UNITED STATES PATENT AND TRADEMARK OFFICE

10/815,993

Office Action Summary	Application No.	Applicant(s)	
	10/815,993	BRONDT ET AL.	
	Examiner	Art Unit	
	Evan Dzierzynski	2875

DETAILED ACTION

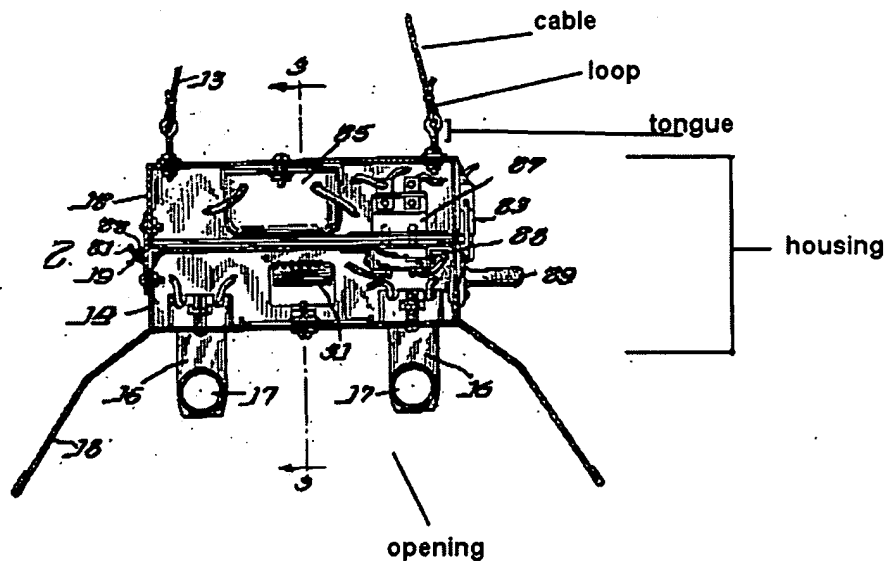
With respect to claims 1 and 3 Westby teaches a lighting fixture (fig 1), comprising a housing supporting a first lamp 17 including a wall and an opening opposite the wall (drawn in below). Westby also teaches a first suspension cable 13 coupled with a housing. The cable includes opposite first and second ends (shown in Fig 1, not numbered) the first end of the suspension cable having a first loop (as indicated below). Westby also teaches a tongue that is formed in the wall of the housing that engages the loop of the cable, and a second tongue formed in the wall that has a second suspension cable that has a loop that engages the second tongue.

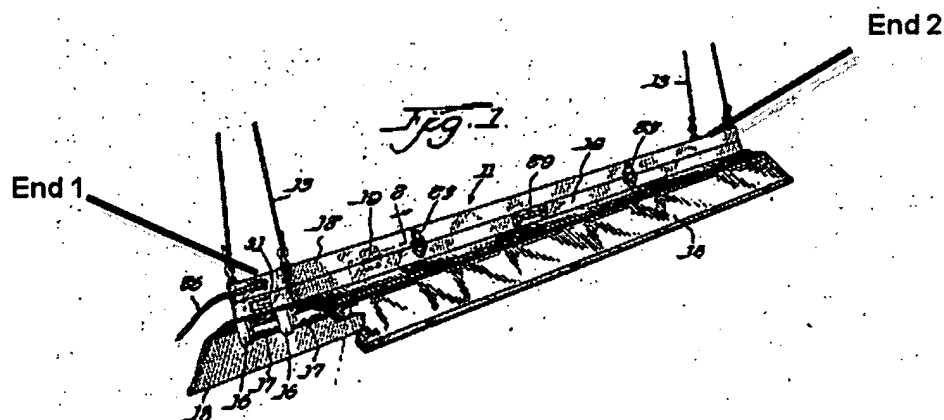
As for claim 4, Westby shows that the wall of the housing includes opposing ends and the first tongue is disposed adjacent to one of the ends (as indicated below).
